MEMORANDUM

To: Kathleen Smith, City of Haverhill
From: William G. Cunniff - Joslin, Lesser + Associates, Inc.
Date: February 16, 2016
Re: Construction Contingency Approval: Caleb Dustin Hunking School
Cc: James F. Scully; Jeffery Luxenberg; Adam Sniegocki

PROJECT#: 131411 - Hunking School

1 MAINTENANCE BUILDING - Option 1

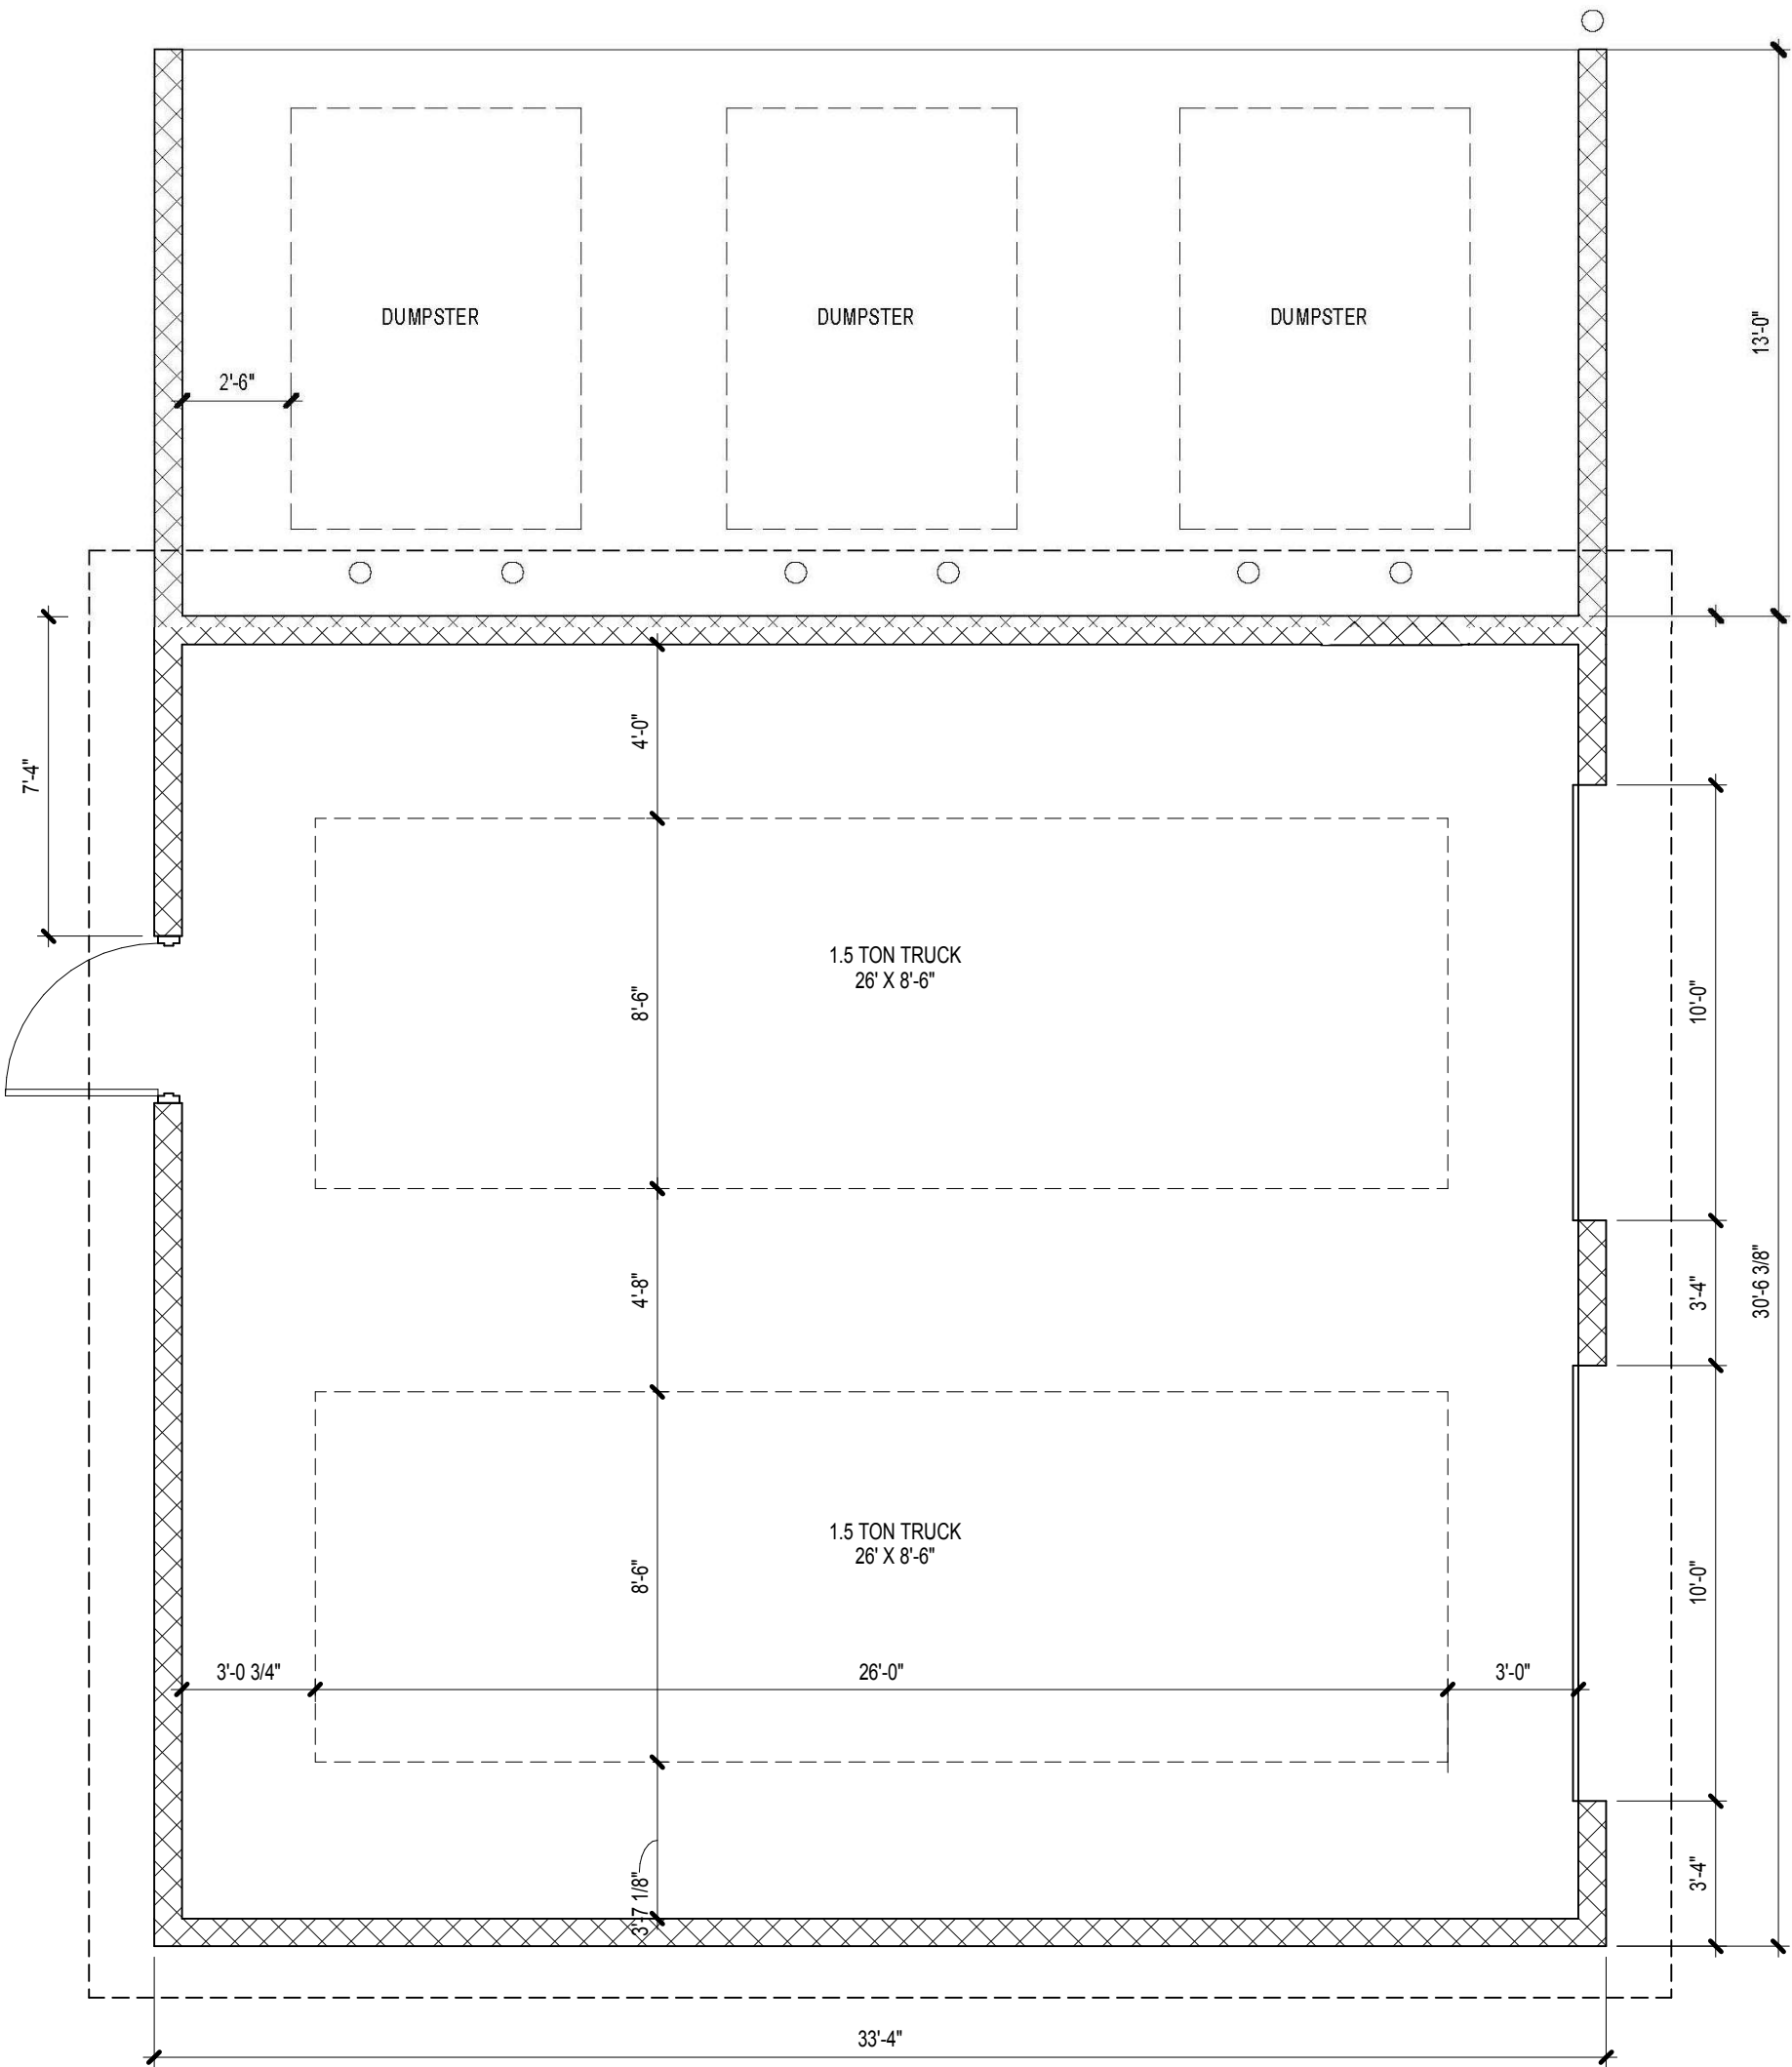
Maintenance Building Allowance - Description of Work	Value \$
This change order request is to fund the incremental increase in costs of the maintenance building, above the value carried in the budget line of the GMP construction budget. This improved design offers the necessary and required storage and service bay capabilities to the Haverhill Public School facilities department.	\$ 248,692.00
\$ 248,692.00

- Option #1 is the simplest of the options and the program includes only two garage bays. This option is approximately 1,015 GSF in size. Each of the two other options builds from that baseline.
- Option #2 adds approximately 270 GSF in the form of a separated room to serve multiple functions. 1,285 is the total approximate GSF
